**VENETIAN**
**SUBDIVISION AT CHILDERS ROAD**
COBB COUNTY, GEORGIA
L.L. 28, 1st. DIST., 2nd SECTION
Prepared For
PAUL AMINA

REZONING
PLAN

**PETITION NO:** Z-6

**PLANNING COMMENTS:** **Staff Member Responsible:** John P. Pederson, AICP

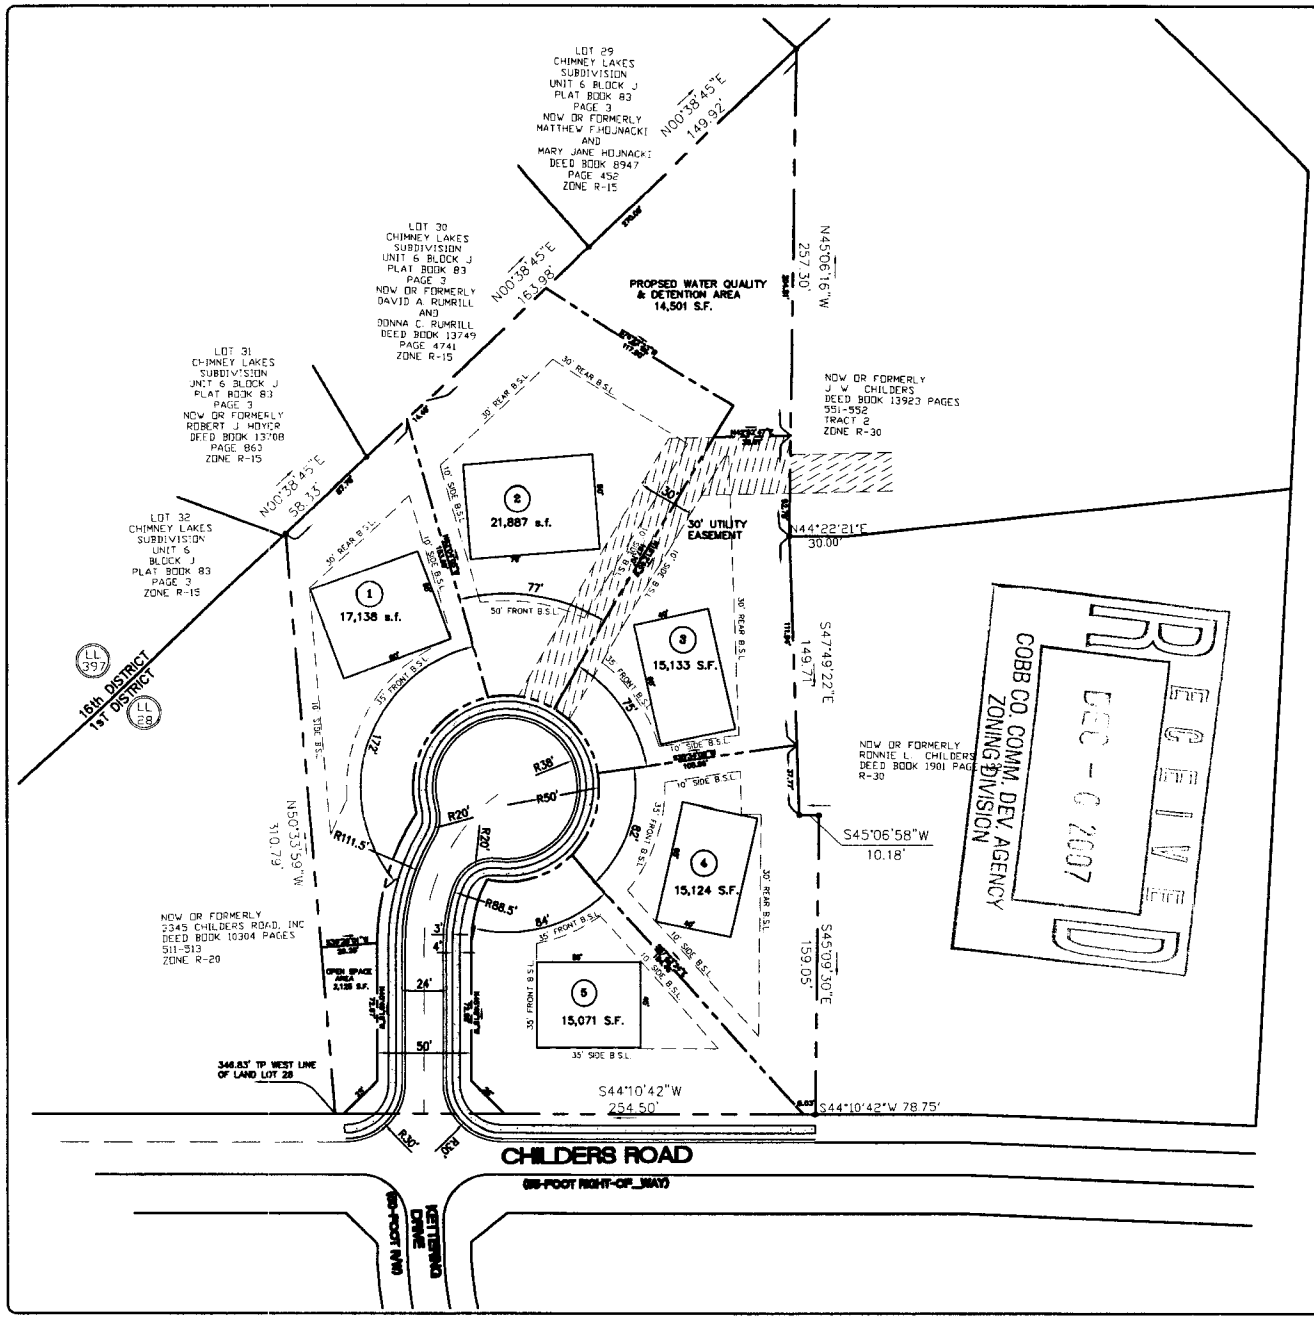
Developer may be required to install/upgrade water mains, based on fire flow test results or Fire Department Code. This will be resolved in the Plan Review Process.

Sewer extension by developer required to upper property line.
Sewer also available 435 ft NE, approx; easements required

1. As indicated in the Downstream Conditions Comments, Lower Chimney Lake is located approximately 600 feet downstream from the site. A pre- and post-development sediment study will be required.
2. The proposed detention pond is located immediately to the rear of two existing homes within the adjacent Chimney Lakes S/D. The landscape plan must include suitable vegetative to provide adequate screening for these existing home owners. If a wall is required to meet detention requirements, the wall must be decoratively faced with masonry or form-liners used to provide an aesthetic view.
3. The detention pond lot must be extended with a 20-foot " flag" to the public R/W to provide adequate pond maintenance access.

Childers Road is classified as a Minor Collector and according to the available information, the existing right-of-way does not meet the minimum requirements for this classification.

Install sidewalk, curb and gutter along the road frontage.

Recommend applicant consider entering into a development agreement pursuant of O.C.G.A. 36-71-13 for dedication of the following system improvements to mitigate traffic concerns: a) donation of right-of-way on the north side of Childers Road, a minimum of 30' from the roadway centerline.

Recommend installing sidewalk, curb and gutter along the road frontage.

Based on the above analysis, Staff recommends APPROVAL subject to the following conditions:

- Site plan received by the Zoning Division December 6, 2007, with the District Commissioner approving minor modifications;
- Fire Department comments;
- Water and Sewer comments and recommendations;
- Stormwater Management comments and recommendations;
- DOT comments and recommendations;
- owner/developer to enter into a Development Agreement pursuant to O.C.G.A. §36-71-13 for dedication of system improvements to mitigate traffic concerns.
